Job: TH - Walled Garden Buildings

Title: Door Details - DTB7 P2
Door Type - B7
Sheet 1 of 3

Type: Building 16 & 16a

Status: FOR PLANNING

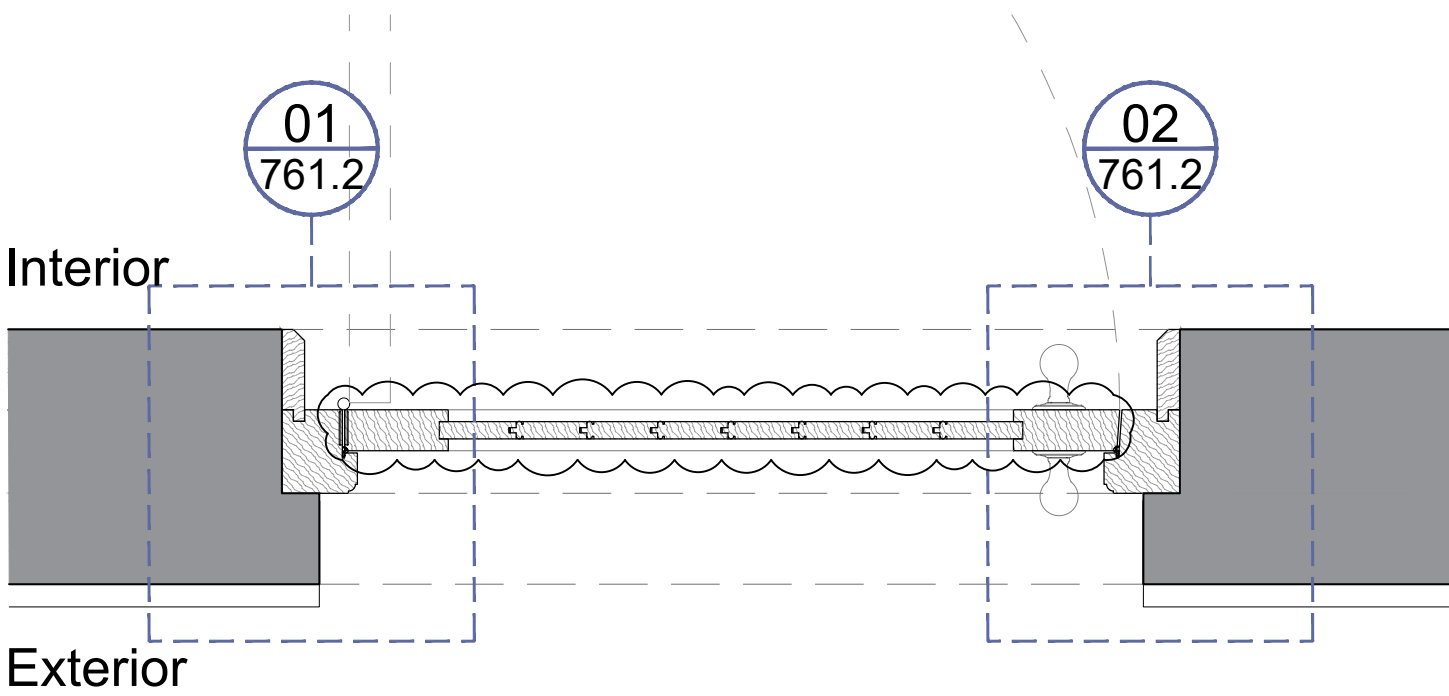
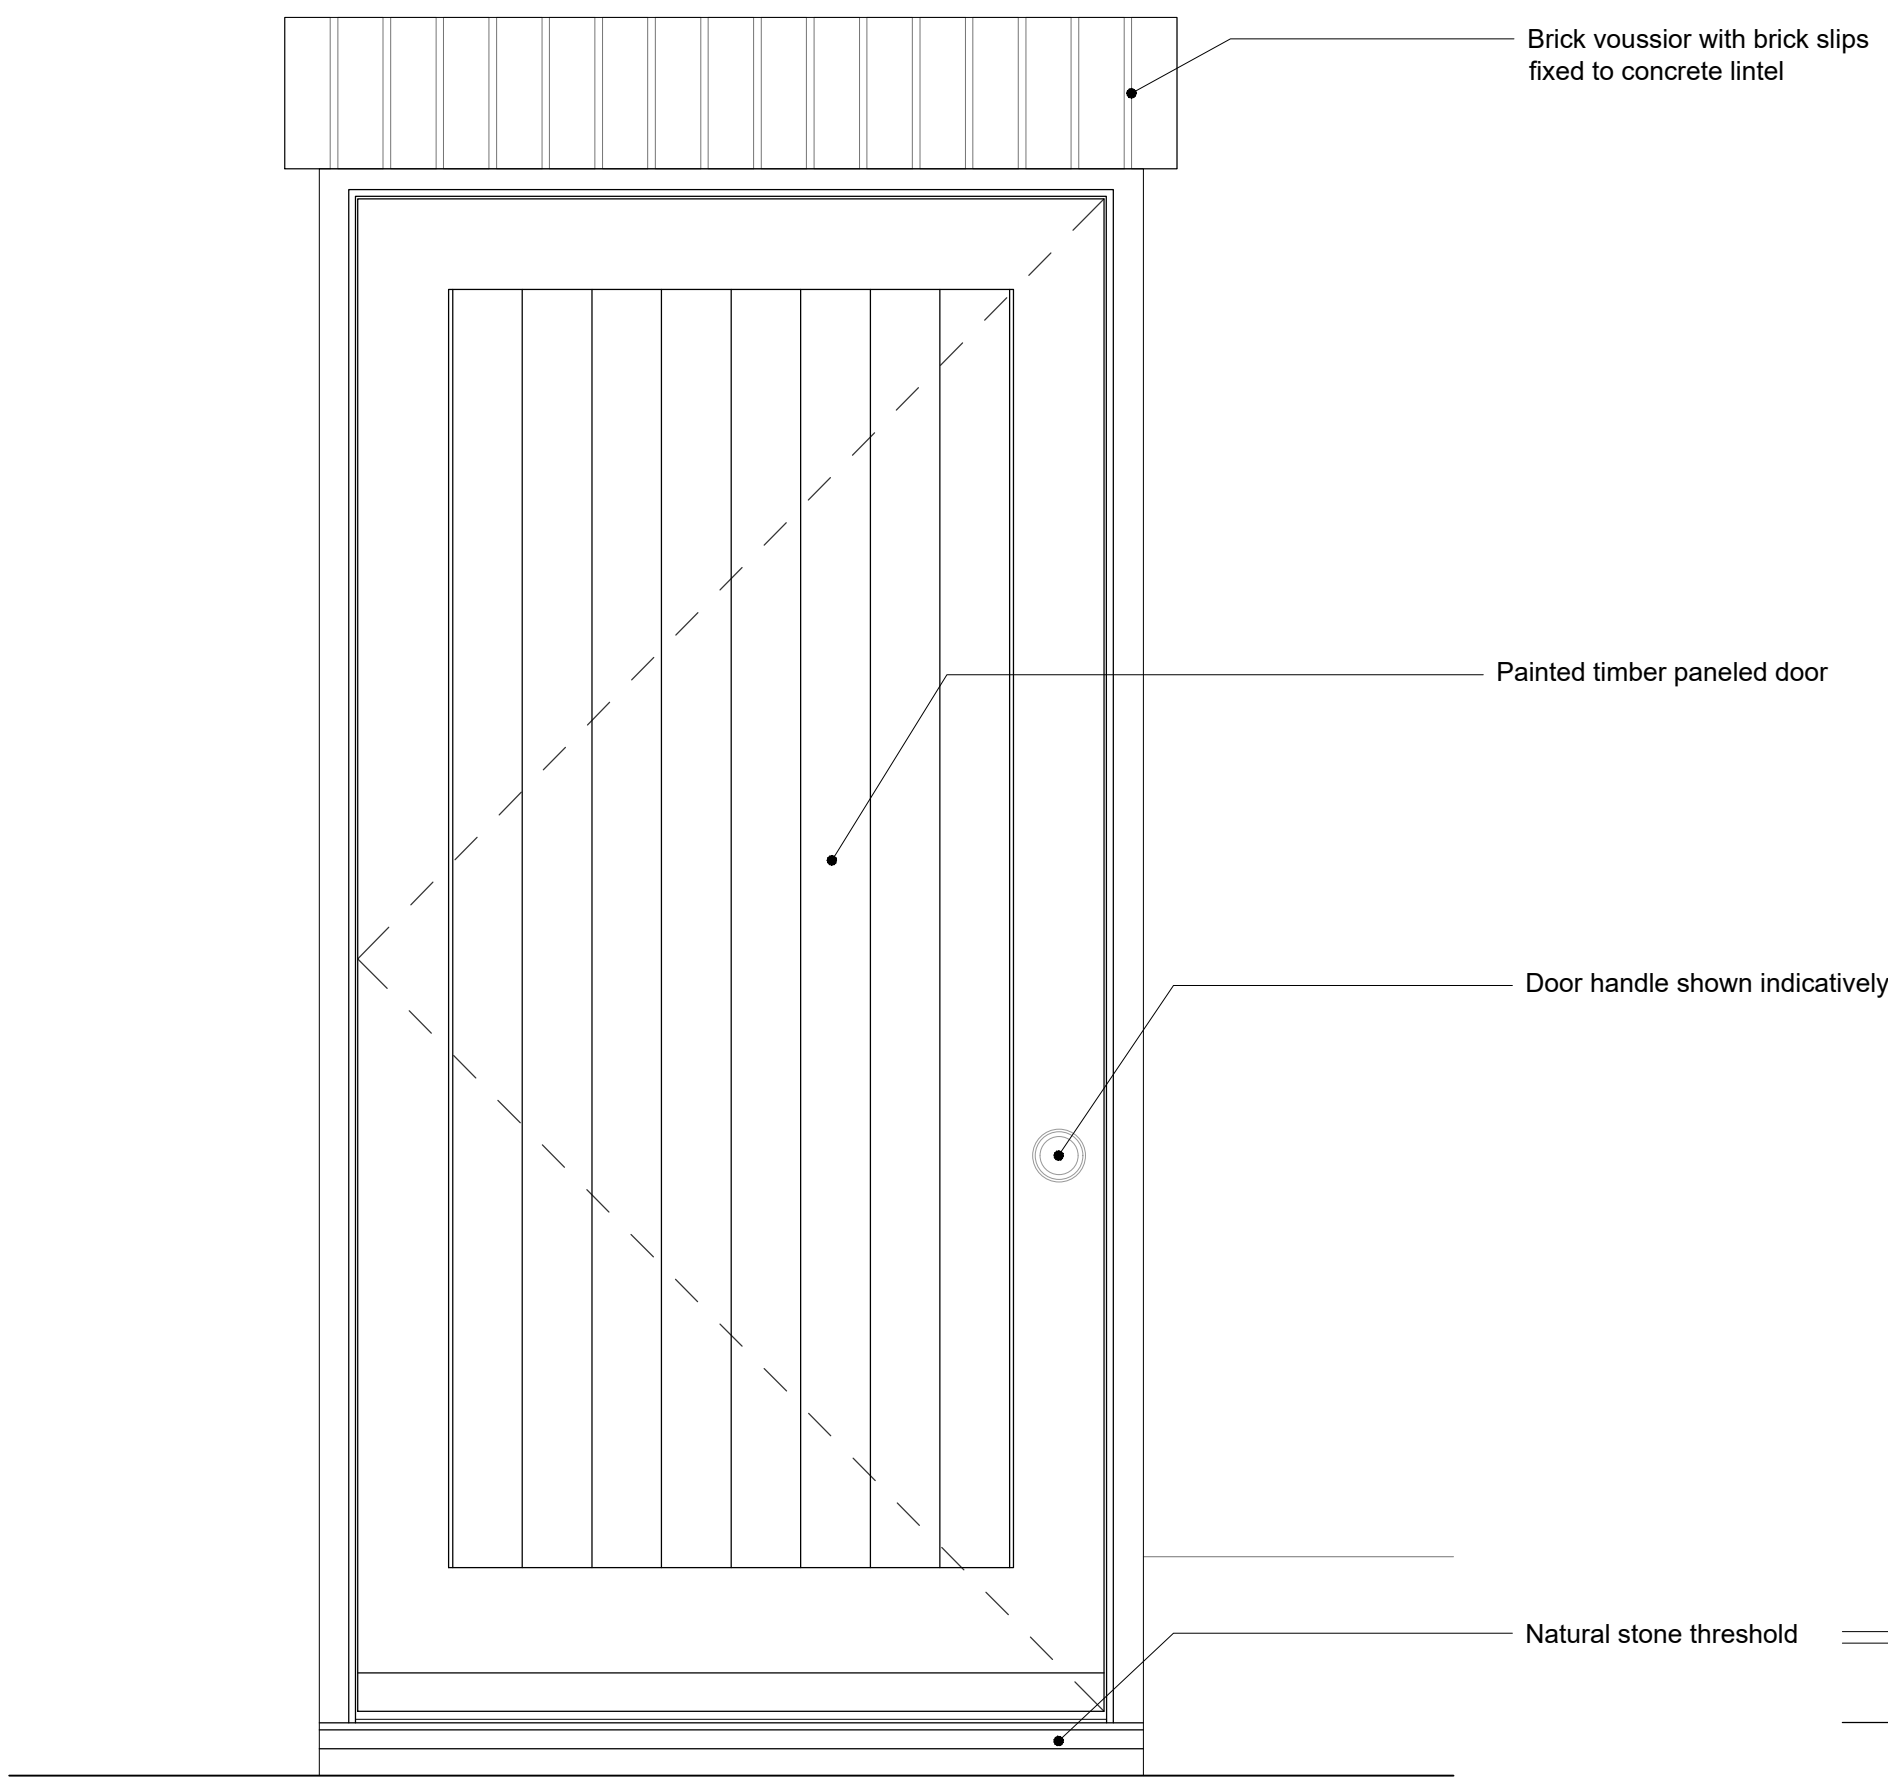
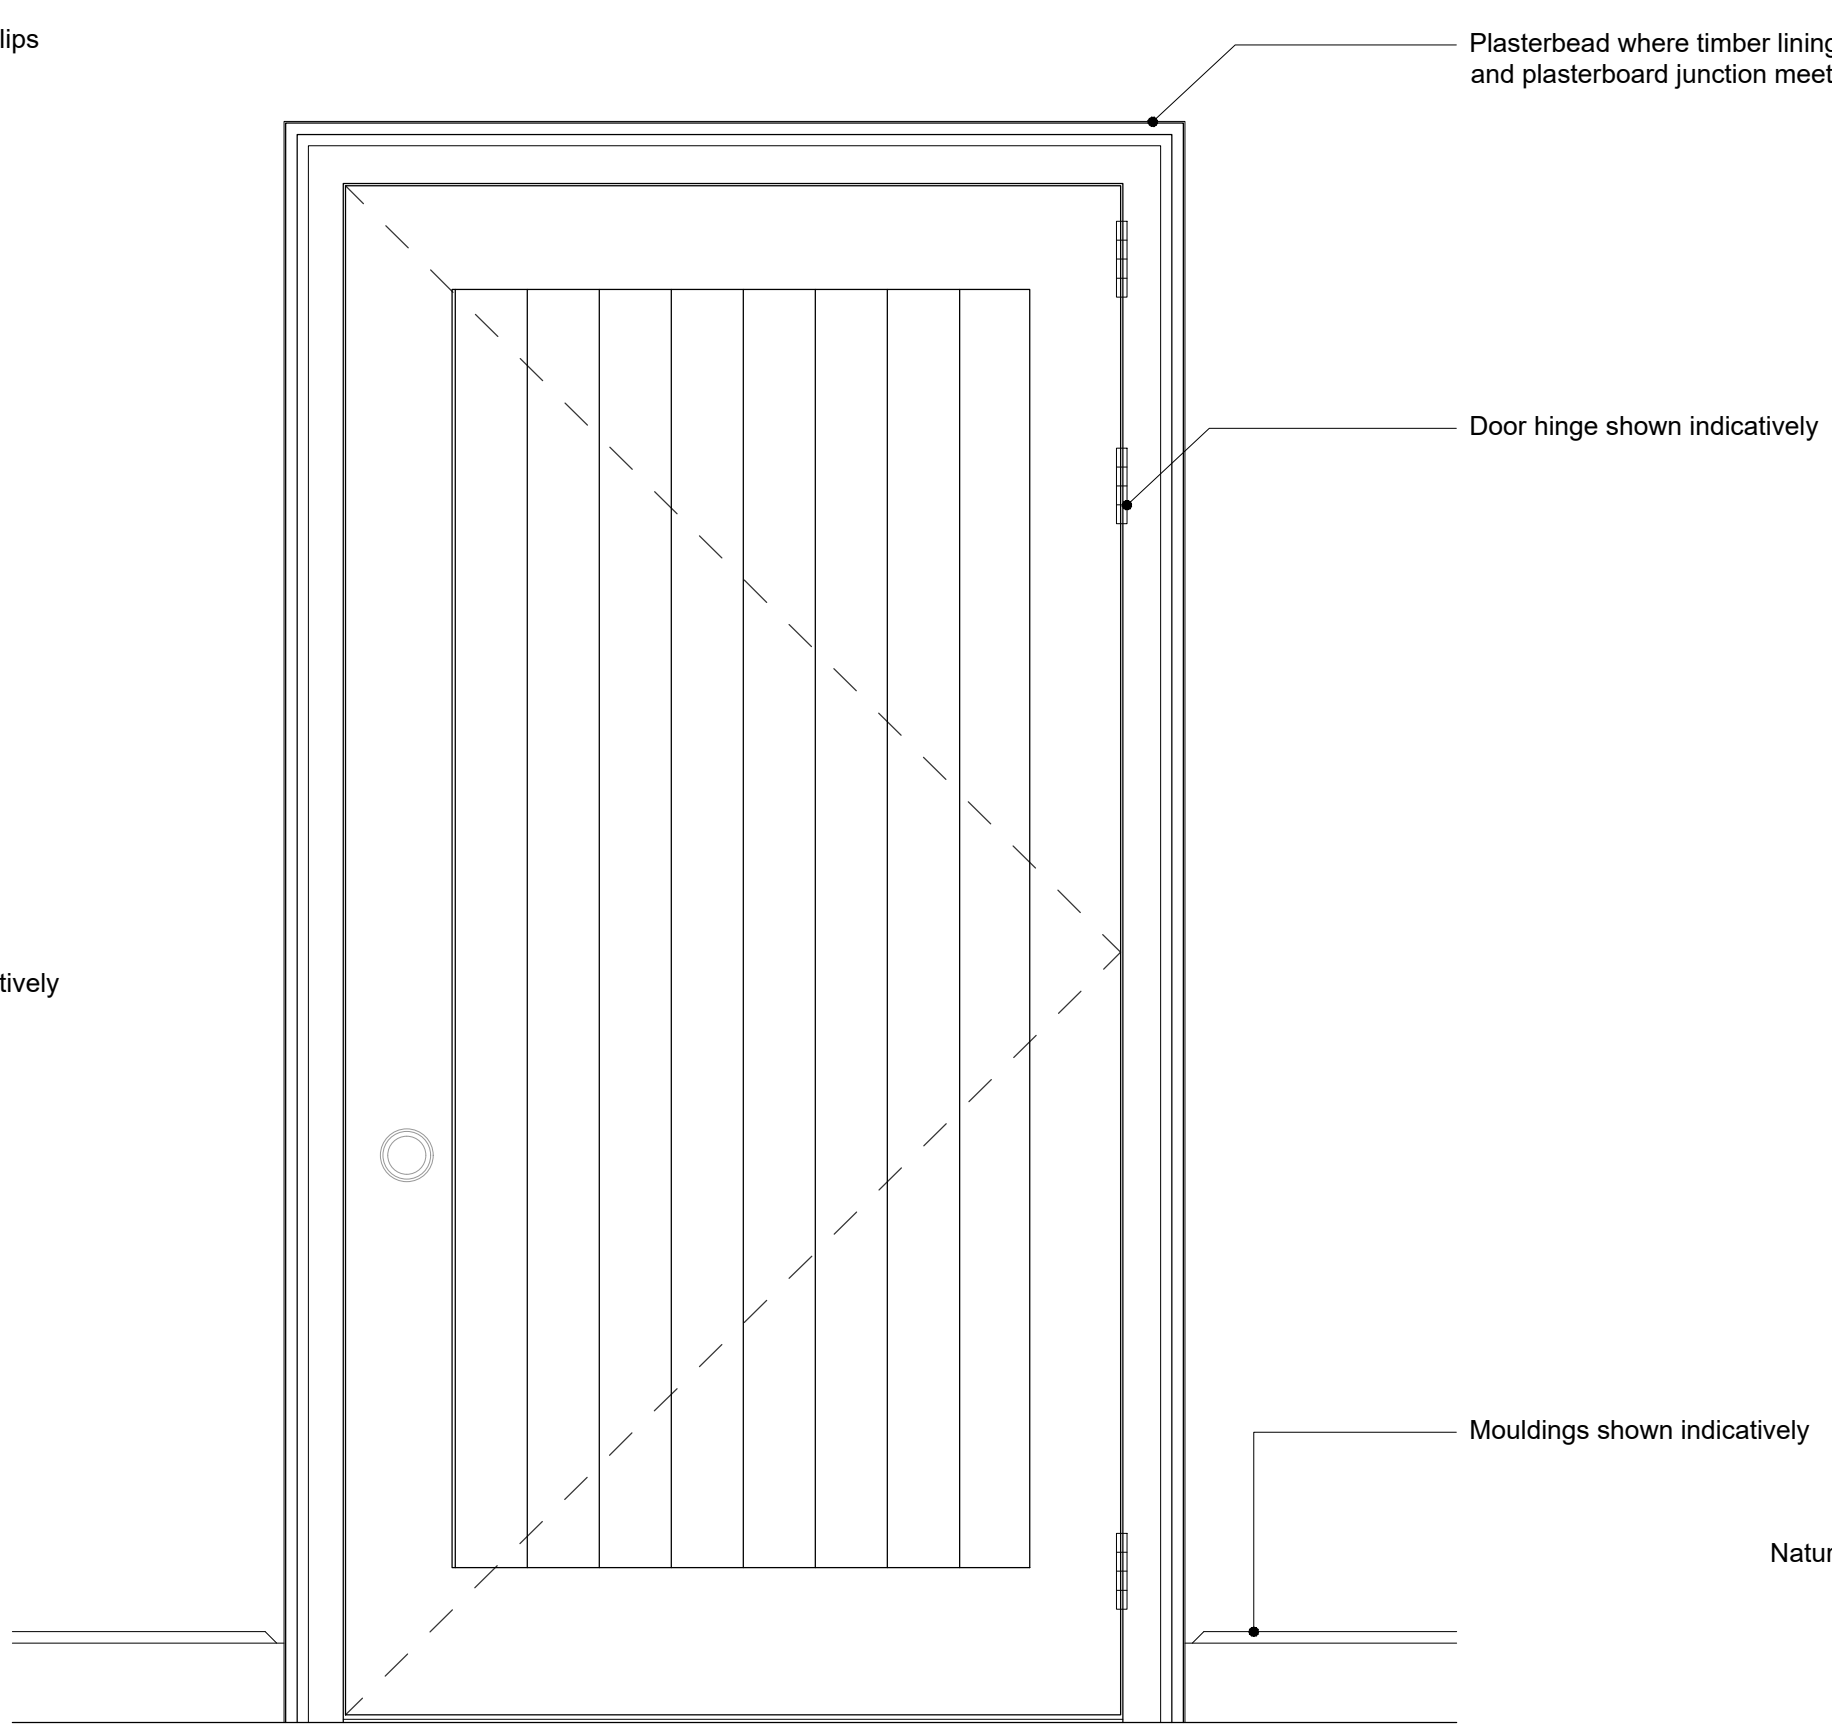
P2	Door amended to traditional timber frame and battened door with beaded detail following officers' comments. Details titles updated.	07/04/26
P1	Initial Release	dd/mm/yy
no.	revision.	date.
